PLANNING COMMISSION STAFF REPORT

Merrimac Flats
Planned Development Petition 410-07-45
Subdivision Petition 490-08-07
1440 S Richards
(1419 S Richards and 38 W Merrimac).
March 26, 2008

Petition 410-07-45 – A request for Planned Development approval for site plan and design approval.

Petition 490-08-07 – A request for Subdivision approval.

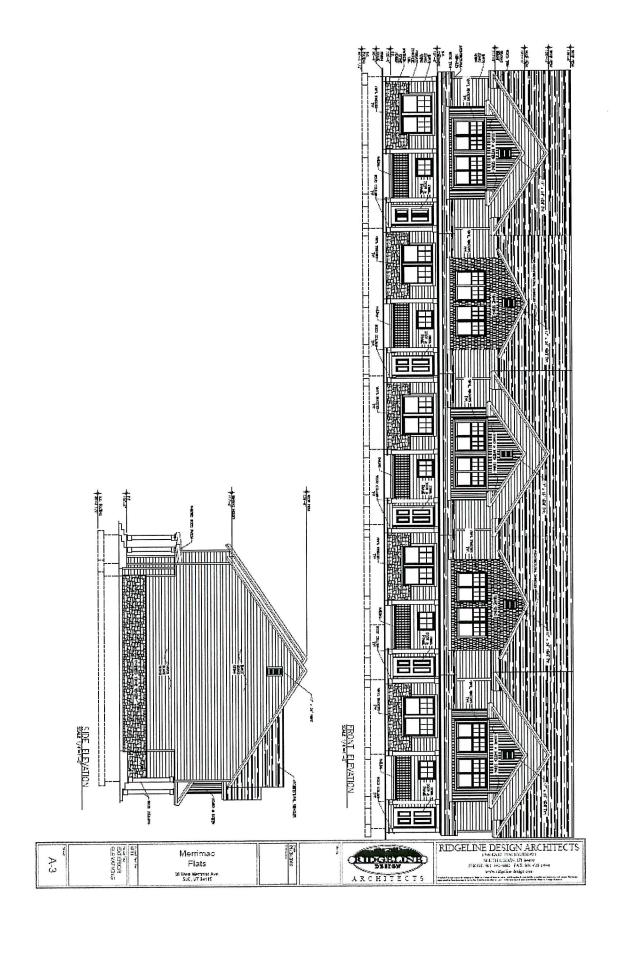
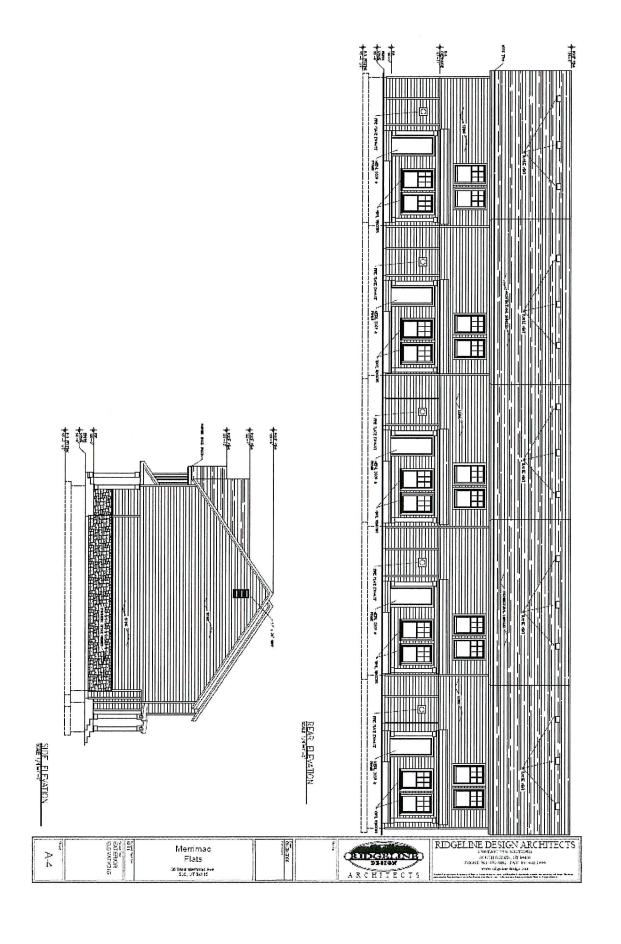
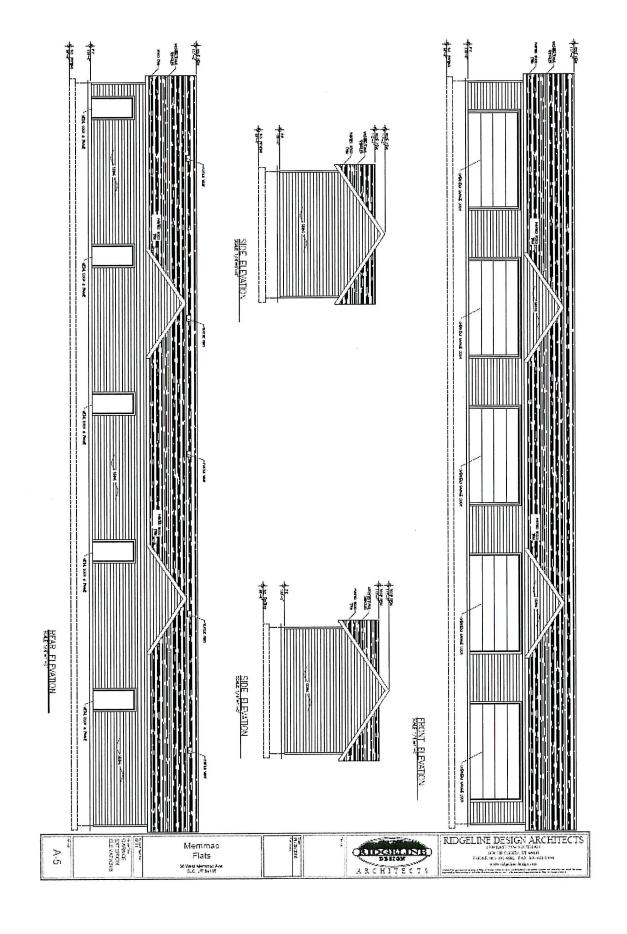
The site plan needs to be revised to provide the minimum back out area for each garage parking space. Drainage needs to be addressed so that the common driveway does not surface drain across the public sidewalk.

- 7. Provide a Landscape Plan showing front yard, corner side yard and park strip landscaping.
- 8. Public Utilities approval required.
- 9. Transportation Division approval required for all parking and traffic-related issues. The detached garages do not meet the minimum 22' 7" back out distance required.

The site plan needs to be revised to provide the minimum back out area for each garage parking space. And drainage needs to be addressed so that the common driveway does not surface drain across the public sidewalk.

- 18. Provide a Landscape Plan showing front yard, corner side yard and park strip landscaping.
- 19. Public Utilities approval required.
- 20. Transportation Division approval required for all parking and traffic-related issues. The detached garages do not meet the minimum 22′ 7″ back out distance required.
